# ICC A117.1 Comments on 2<sup>nd</sup> Draft

Proposal list to the 2017 A117.1 for the 2023 edition –  
03-30-2025  
Chapter 6

## CHAPTER 6 PLUMBING ELEMENTS AND FACILITIES

Figure C608.2.1.2(b)  
TRANSFER SHOWER WITH DRESSING ROOMS

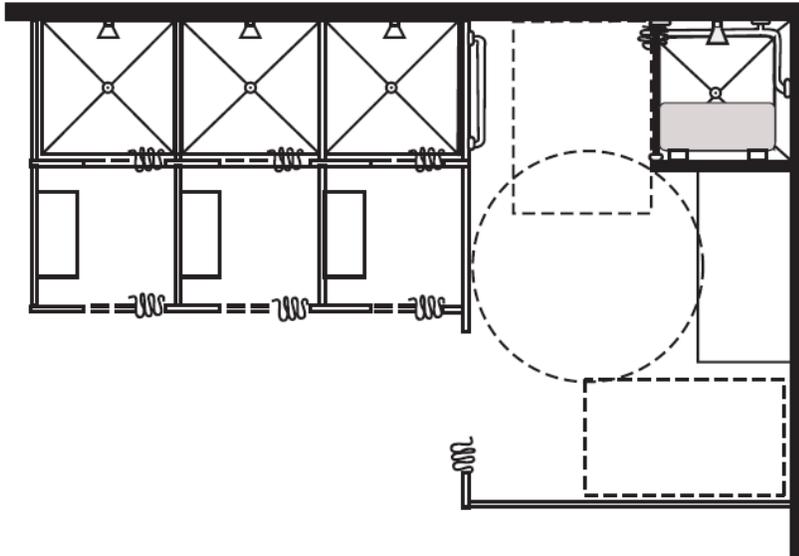
This figure is in the 2017 ICC A117.1 commentary.

**Committee Reason:** The modification brought forward is more technically accurate than the approved text. This will ensure that where there are changing spaces in front of shower stalls that this amenity will also be available for the accessible shower.

**FIGURE 604.4**  
**WATER CLOSET SEAT HEIGHT**

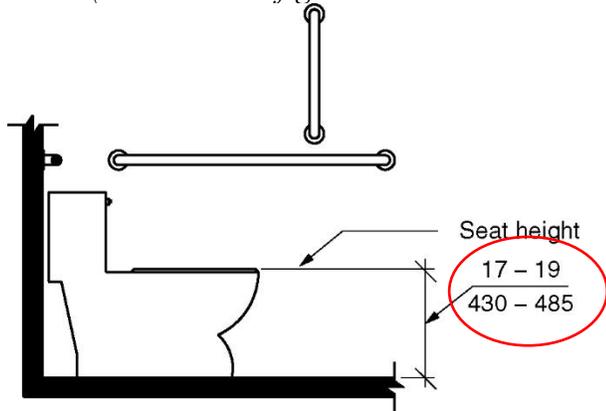
(Note: Revise figure 604.4 to show 17-20)

~~**FIGURE 703.6.2.2**  
**SYMBOL FOR INJURED PERSONS**~~

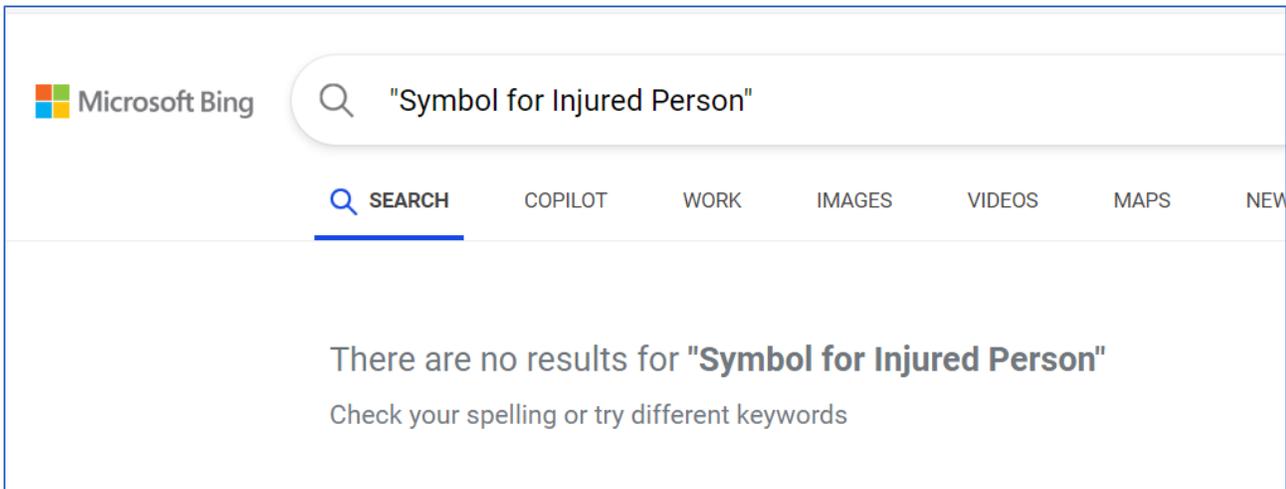
~~703.6.2.2 Symbol for injured persons. The Symbol for the Injured Persons shall comply with Figure 703.6.2.2.~~

**FIGURE 607.2(A)**  
**TRANSFER CLEARANCE FOR BATHTUBS WITH REMOVABLE IN TUB SEATS**

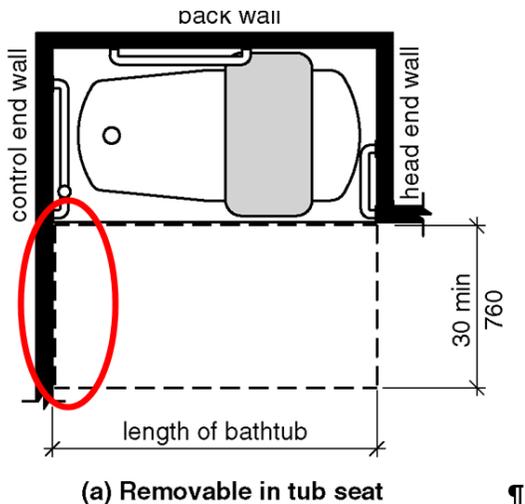
*Note: The wall in the Figures 607.2(A) and 607.2(B) would be jogged to indicate the additional 4 inch toe clearance in the new Figure 607.3. The committee will need to decide if Figures 607.2(A) and 607.2 (B) should be revised to show the control clearance with the transfer clearance or if the control clearance should be in a separate Figure 607.3. The figure submitted indicates the transfer clearance moving forward, not an addition 4 inch control clearance as the text indicates.*

**FIGURE 607.5**  
**LOCATION OF BATHTUB CONTROLS**

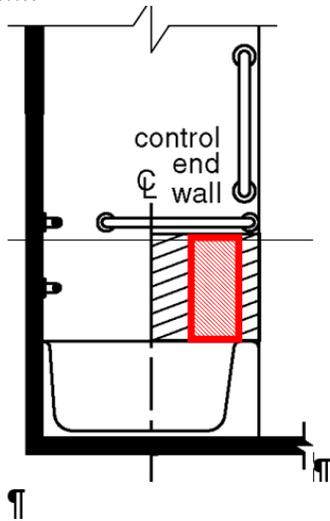
*Note: The area for the controls in Figure 607.5 would be revised to the smaller area indicated in the revised text.*

**Figure 1103.11.2.5.1(A)  
CLEARANCE FOR BATHTUBS IN TYPE A UNITS WITH REMOVABLE SEATS**

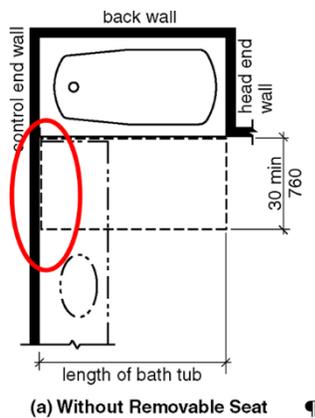
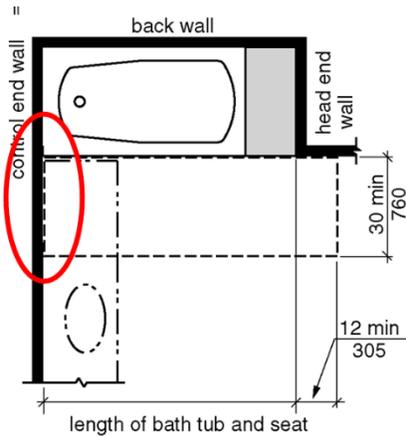
Note: The wall in the Figures 1103.11.2.5.1(A) and 1103.11.2.5.1(B) would be jogged to indicate the additional 4 inch control clearance in the new Figure 607.2.1

**FIGURE 607.5  
LOCATION OF BATHTUB CONTROLS**

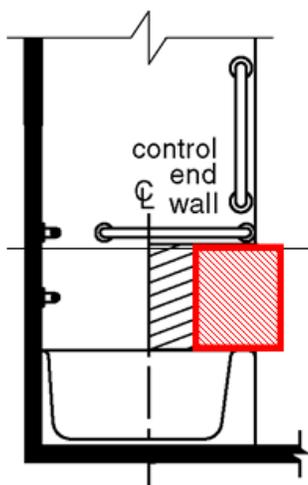
*Note: The area for the controls in Figure 607.5 would be revised to the smaller area indicated in the revised text. 9" is from the clear floor space, not from the front of the tub.*

**Figure 1103.11.2.5.1(A)**  
**CLEARANCE FOR BATHTUBS IN TYPE A UNITS WITH REMOVABLE SEATS**

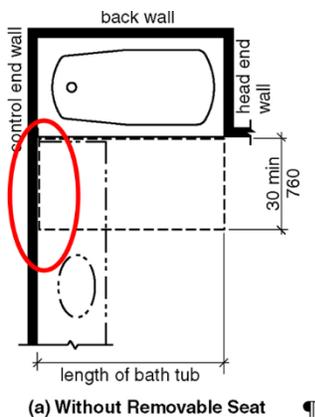
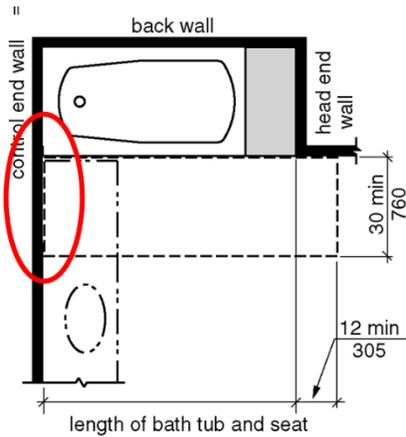
*Note: The wall in the Figures 1103.11.2.5.1(A) and 1103.11.2.5.1(B) would be jogged to indicate the additional 6-inch control clearance in the new Figure 607.3*

**FIGURE 611.7(B)**  
**ROLL-IN SHOWERS FOR ASSISTED BATHING**  
**OPTION 2**

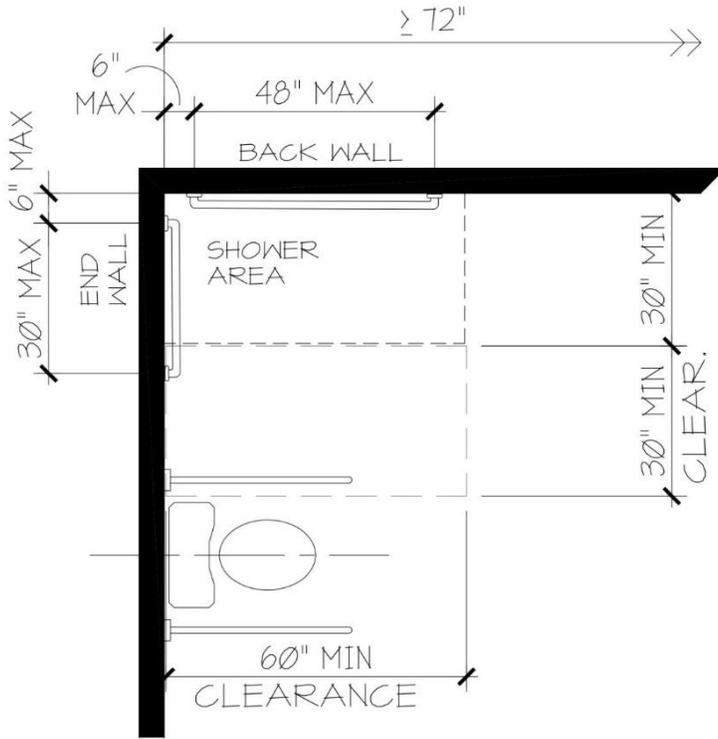
*Figure should show grab bars as 48" minimum and 30" minimum.*

**Committee Reason:** This change incorporates other changes approved for bathing. The revisions adds clarity. There was a question about Section 611.5.3 Exception 1 – however the strength requirements is only a safety feature for a towel bar; the towel bar does not serve as a grab bar. The minimum and/or maximum on the grab bar lengths needs to be clarified in Figure 611.7 – have editorial look at this.
